PCN-20190717 TE0720-03-1CFA-S Carrier Hardware Revision Change

Company	Trenz Electronic GmbH
PCN Number	PCN-20190717
Title	TE0720-03-1CFA-S Carrier Hardware Revision Change
Subject	Carrier Hardware Revision Change
Issue Date	2019-07-17

This change affects TE0720-03-1CFA-S, which includes carrier TE0703. This carrier is subject to a hardware revision change from TE0703-05 to TE0703-06.

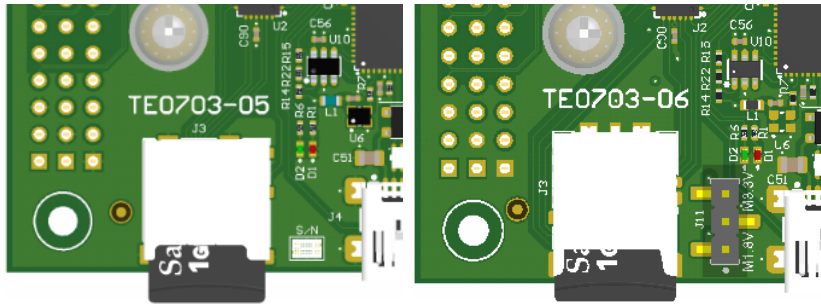
#8 Routing lenght of differential pairs B34_L17, B34_L15, B34_L21, B34_L13, B34_L10, B34_L20 changed

Type: Layout change

Reason: Other changes and limited space on PCB

Impact: Applications with exact timing requirements on these IOs have to be checked and if necessary adjusted
